Delegated Report

Householder Planning Application

Planning Application No: 20230578

Description: Erection of a single storey side and front extension, dormer roof extensions in front and rear roof slope, loft conversion, alterations to fenestration and with an outbuilding.

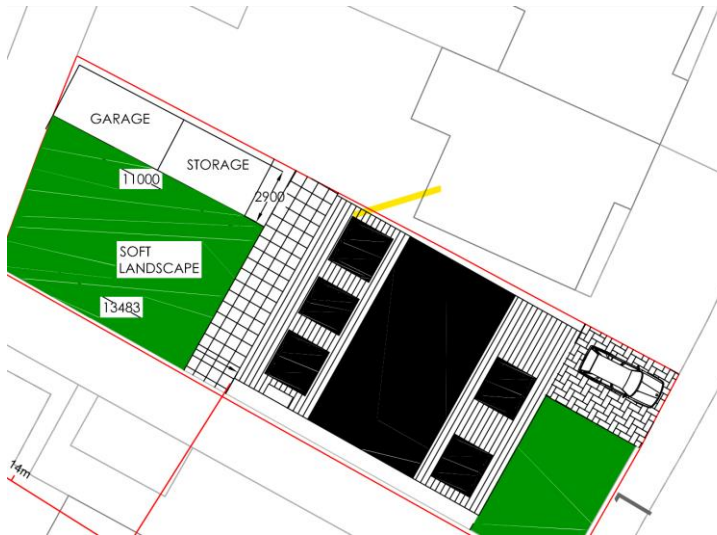
This property has one adjoining neighbour potentially impacted by this development: 3 Marconi Road. This neighbour is located to the northeast. There is a distance of 4-5m between the dwellinghouses side elevations. This would reduce to 1-2m as a result of the development. The proposed outbuilding would be 0.36m from the shared boundary. There is a brick and concrete block wall at the shared boundary. The existing outbuilding is also located on the boundary and this would be removed and replaced with the proposed outbuilding.

A 45 degree test as marked by the yellow line on the image above, shows that the development, being the proposed dormer at the closest and highest point would not overshadow the neighbours windows. The main house itself would maintain a single storey height and so would not result in overshadowing.

The existing dwellinghouse is already 4 metres deeper than this neighbour at its closest point. However, the proposed scheme would result in the dwellinghouse retaining a 4 metres greater depth and as a result of the side extension the bulk of this would be moved to 1 metre from the neighbour's side elevation. This closer proximity and retained greater depth would result in an increased impact on the neighbour in terms of overbearing bulk. However, given the low sloping nature of the roof pitch and the small scale of the dormer extensions, from this neighbour's perspective, the impact would not be significant.
